Proposed design changes following consultation:

Proposed design changes following consultation:

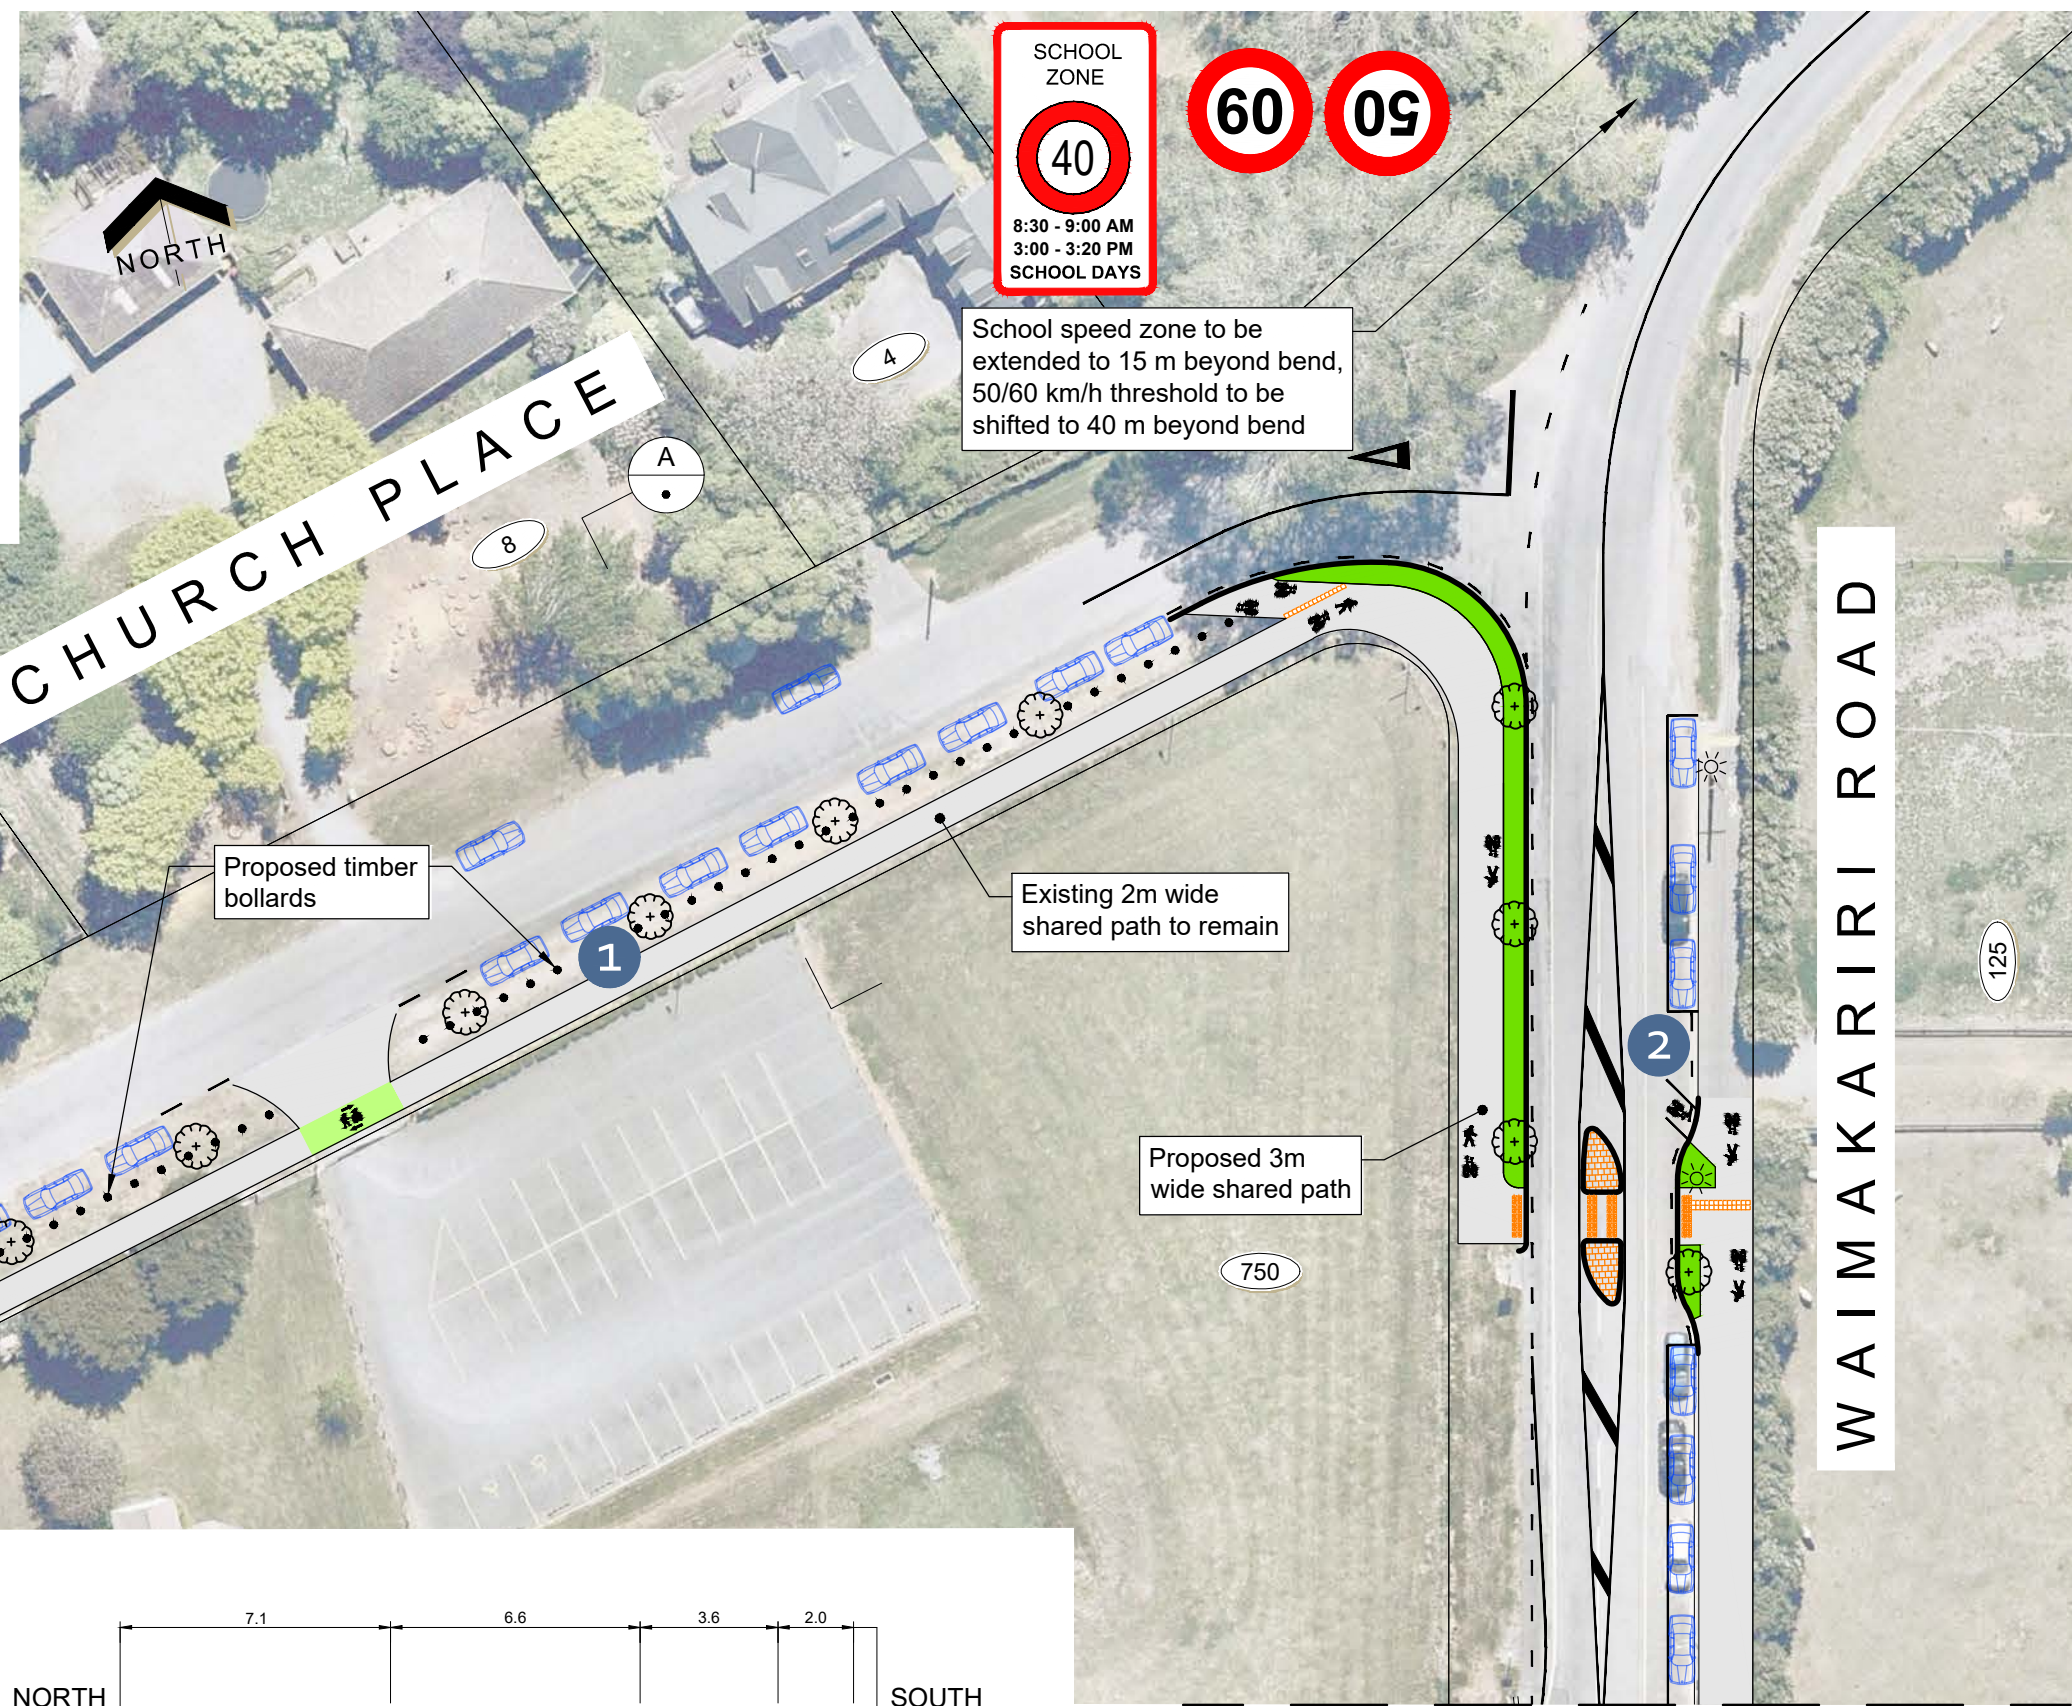
- 1 The proposed post and cable fence is replaced with a row of timber bollards.
- 2 An access onto the shared path for on-road southbound cyclists is added.

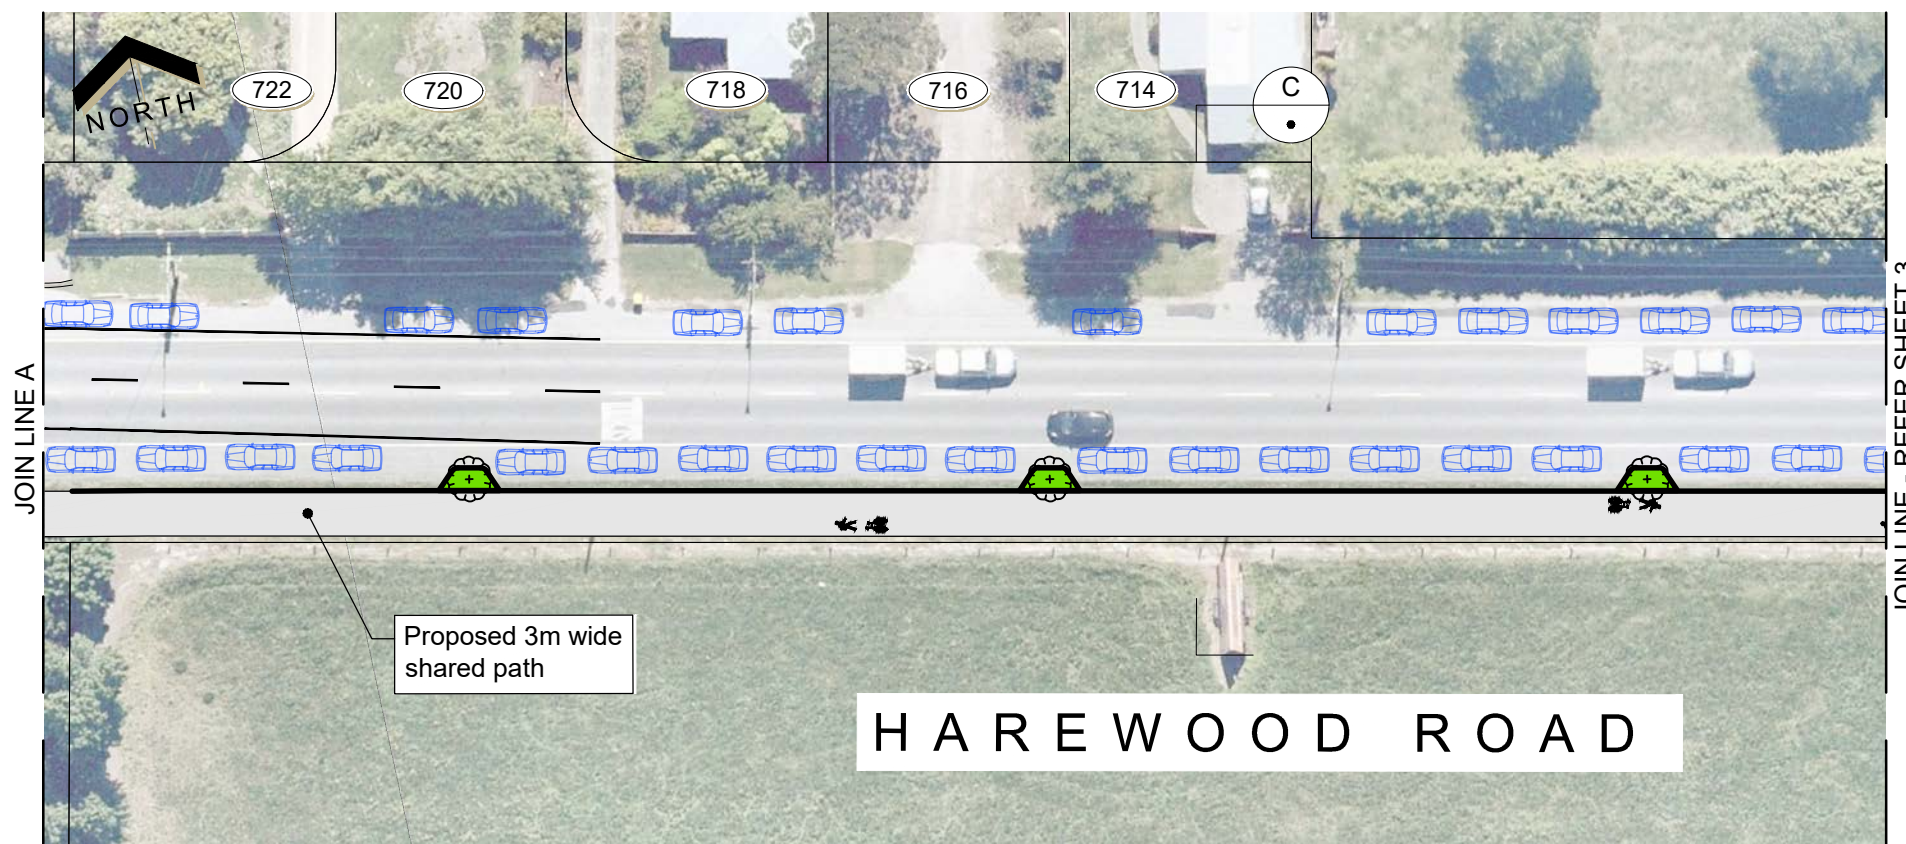
1 The parking is removed from around the driveway access to the garage at No. 705 Harewood Road. The adjacent parking is modified to retain the same number of parking spaces.

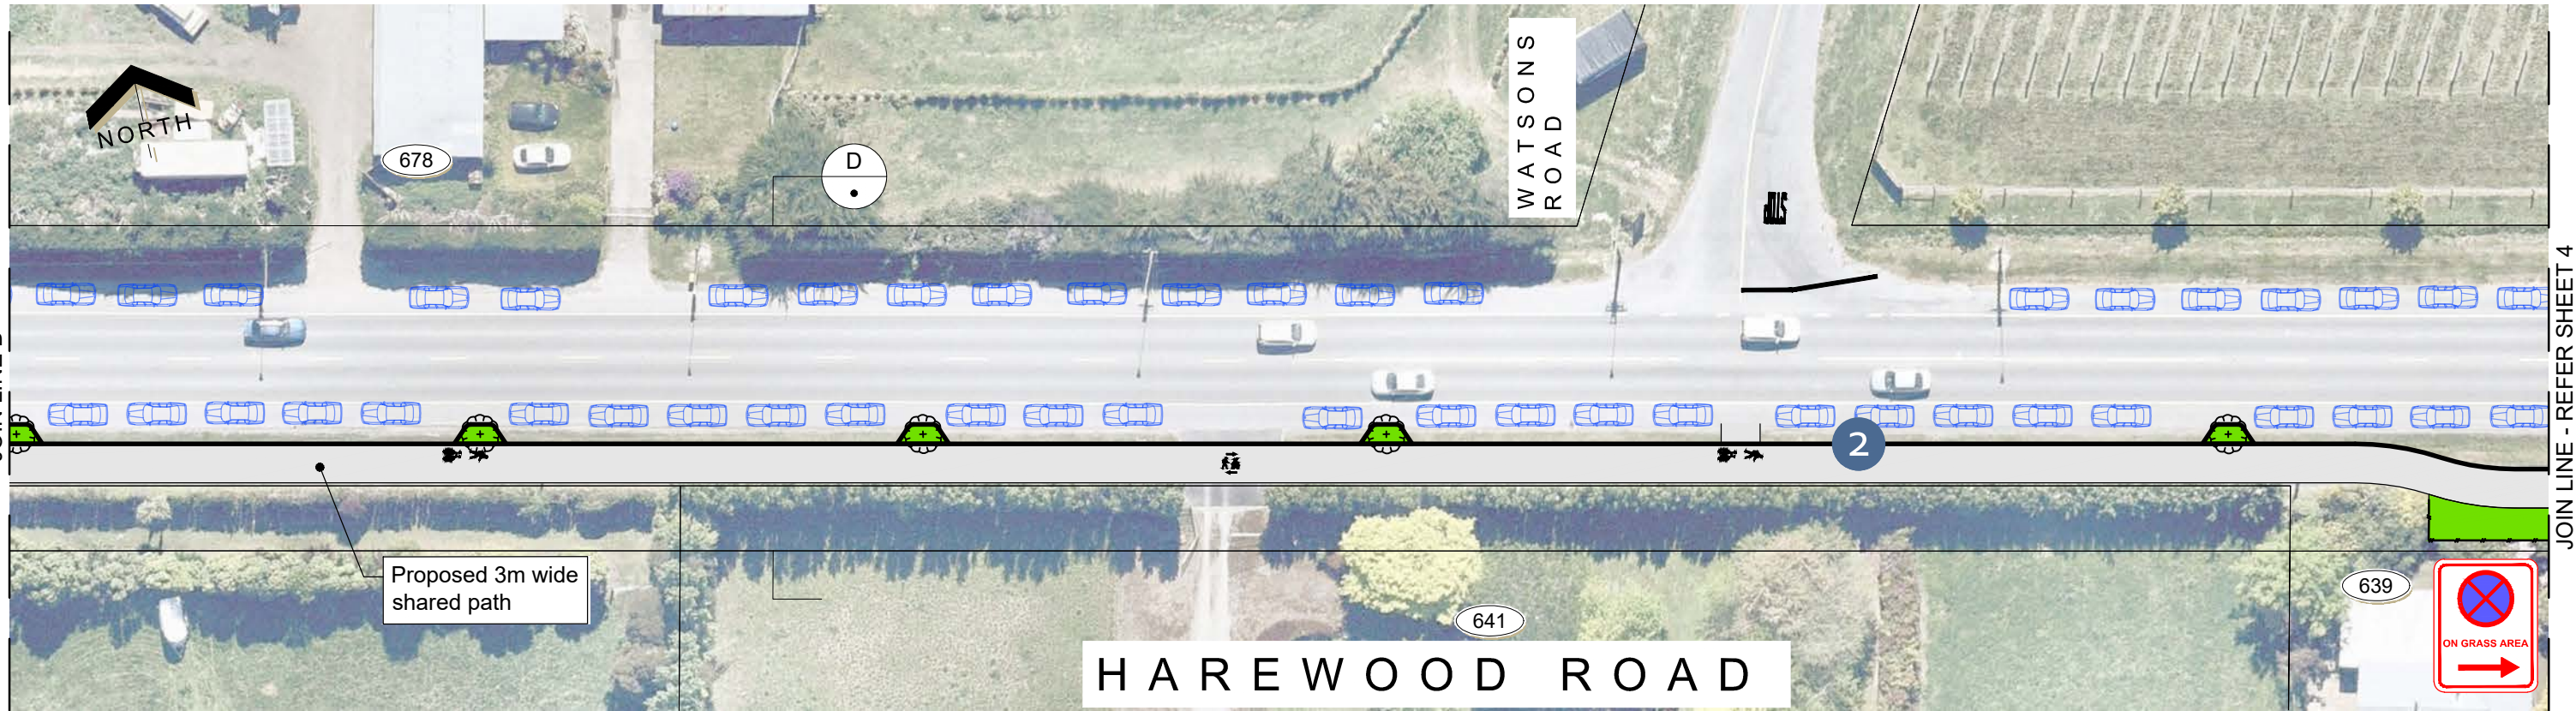
- Proposed design changes following consultation:**
- 1 The two proposed trees at the Stanleys Road intersection are removed from the design.
 - 2 The proposed tree opposite Watsons Road is removed from the design.
 - 3 Ramps are provided on and off Harewood Road so westbound cyclists can take a direct route through the intersection.
 - 4 The shared path crossing at Stanleys Road is set back to allow path users to cross behind a stopped car.

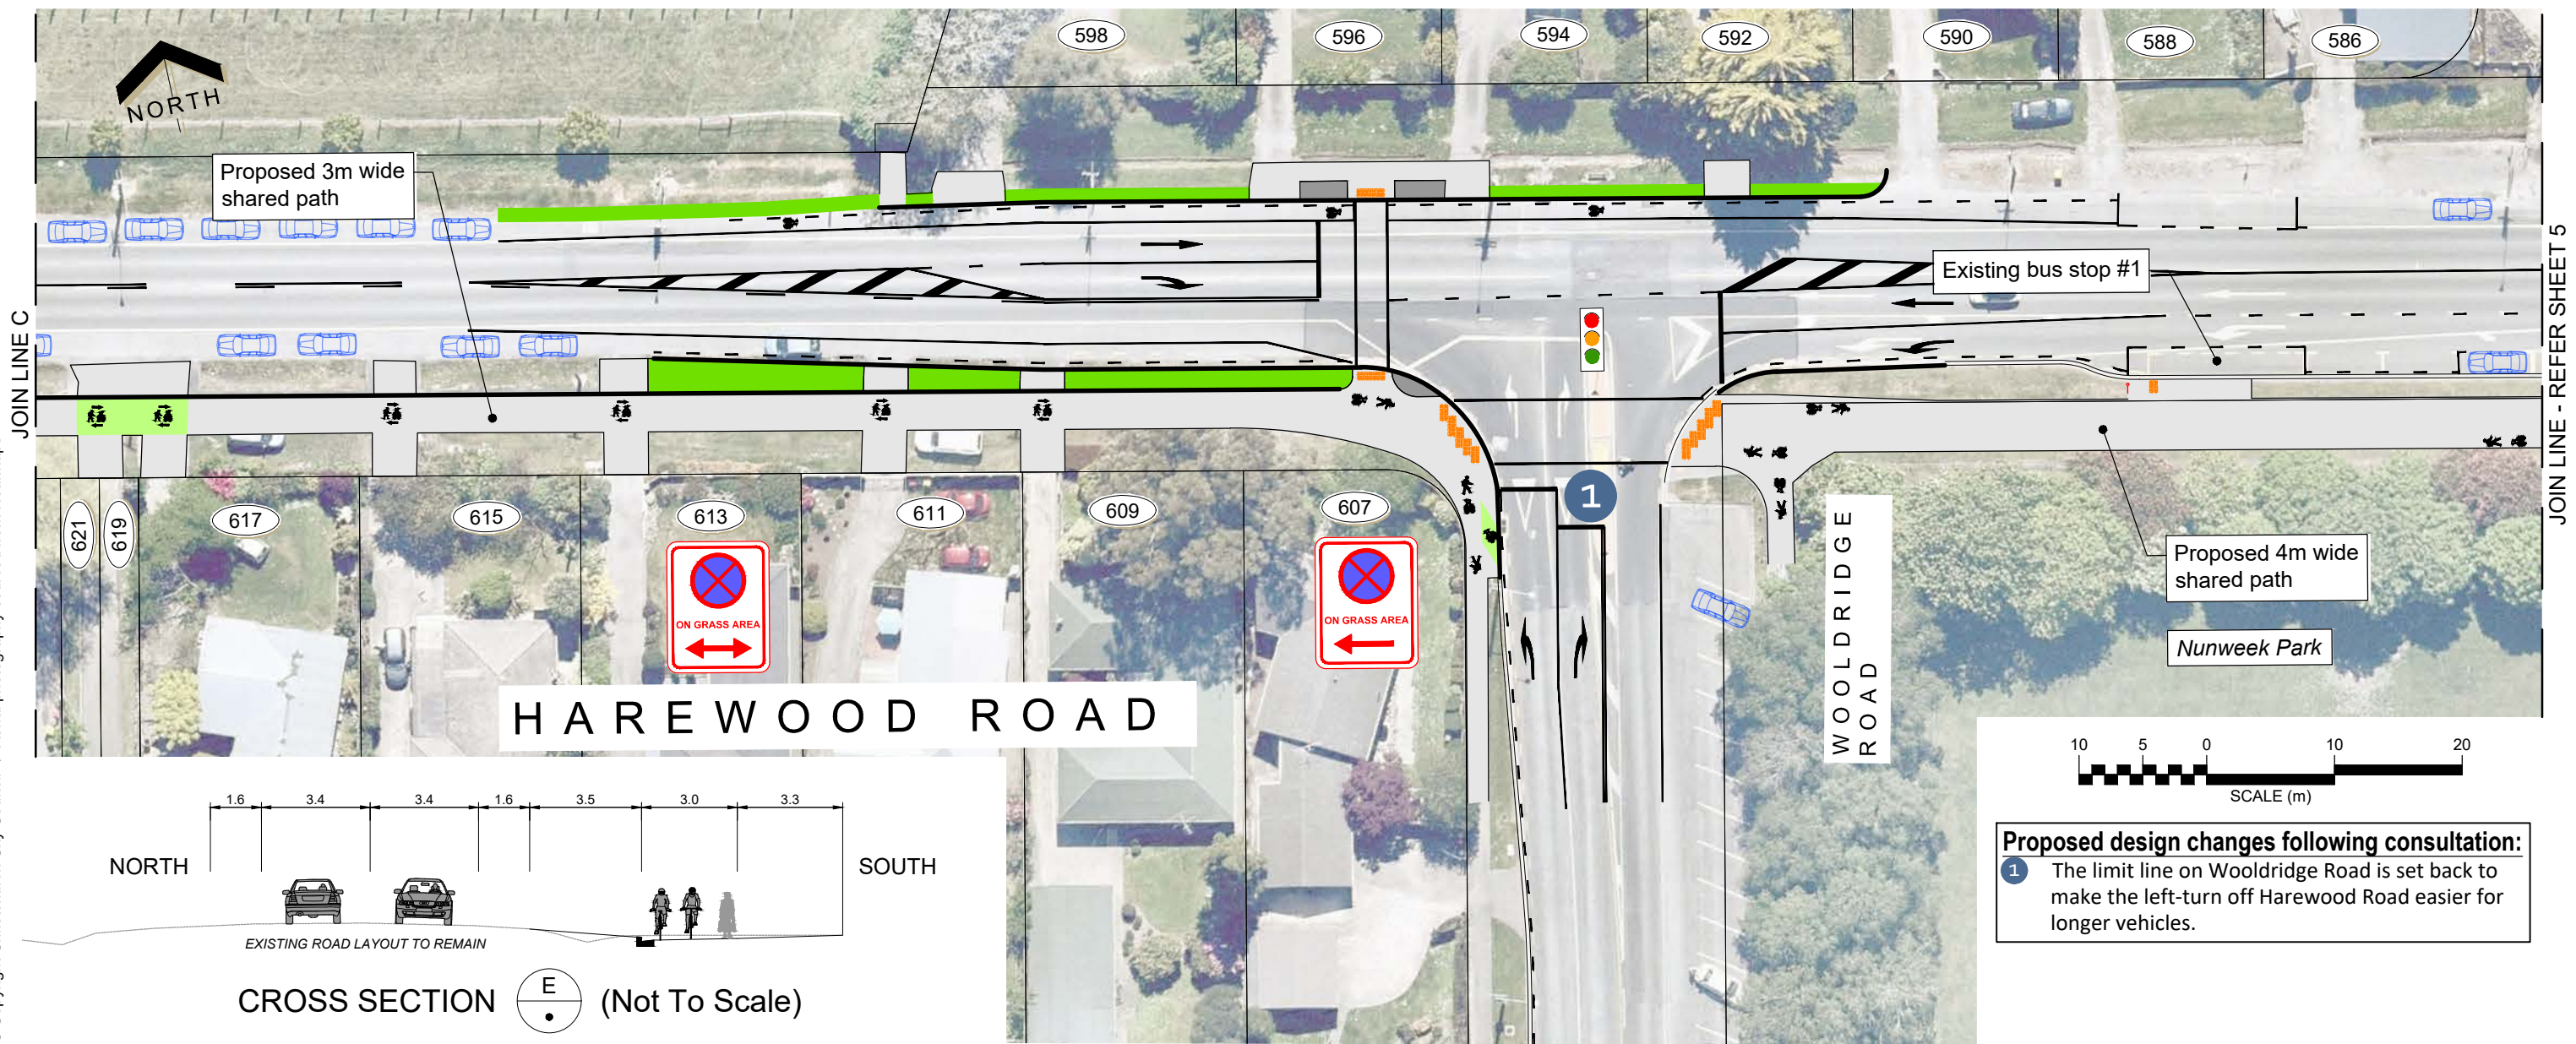
Proposed design changes following consultation:
 1 The limit line on Wooldridge Road is set back to make the left-turn off Harewood Road easier for longer vehicles.
